ATTACHMENT F
RF Safety Evaluation

To: Sean del Solar, City of San Marcos
From: Jonathan L. Kramer *Jonathan Kramer*
Date: October 10, 2011
RE: Case No. CUP 03-607 (AT&T Mobility)
1441 North Twin Oaks Valley Road
"Twin Oaks Golf Course"

Figure 1: Existing signal coverage map. (Source: AT&T). See discussion below regarding the unreliability of this figure.

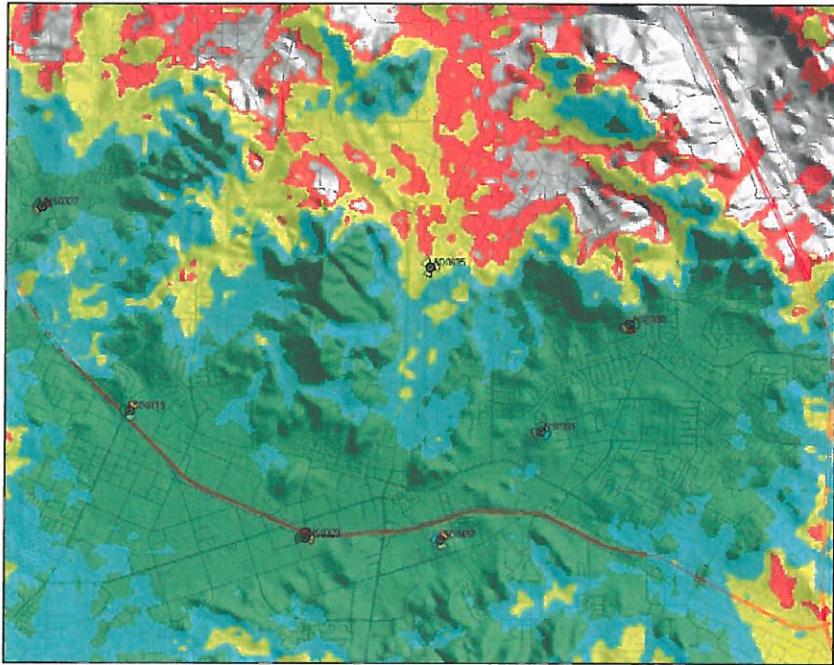
AT&T's computer-projected existing coverage map (Figure 1, below) tendered to the City, does not contain signal level data. Figure 1 does, however, contain coverage information but AT&T has not provided any information indicating

what each color on the coverage map indicates or which band(s) of service the coverage map represents. The coverage maps provided are unreliable.

Although the current coverage map in Figure 1 does not indicate whether there is a lack of LTE coverage in the area (in fact, the lack of technical detail such as bands and signal levels on the map makes the map all but meaningless from a RF engineering viewpoint), I am aware that AT&T is just starting to deploy sites on the 751 MHz LTE band, therefore the current project is consistent with an initial build-out for the new LTE network. Accordingly, it is my current opinion that there is a gap of LTE-band coverage in the proposed area. I do not express an opinion as to the signal coverage levels for any other bands of service.

Figure 2: Projected signal coverage with proposed site and other sites proposed for the San Marcos area. (Source: AT&T). See discussion below regarding the unreliability of this figure.

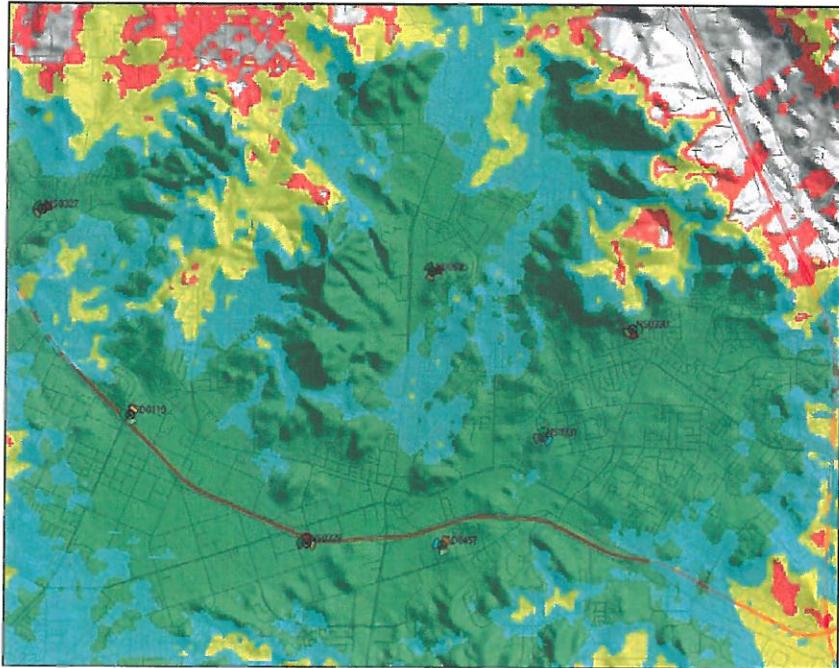
Figure 2 depicts what AT&T purports to be the proposed coverage with the proposed site online. However, like Figure 1, the coverage map in Figure 2 does not indicate which bands of service or what signal levels are represented, and is, as is Figure 1, meaningless. Therefore, I am unable to form a reasoned conclusion as to the signal coverage provided by the proposed project as AT&T has provided no technical basis for such a conclusion.
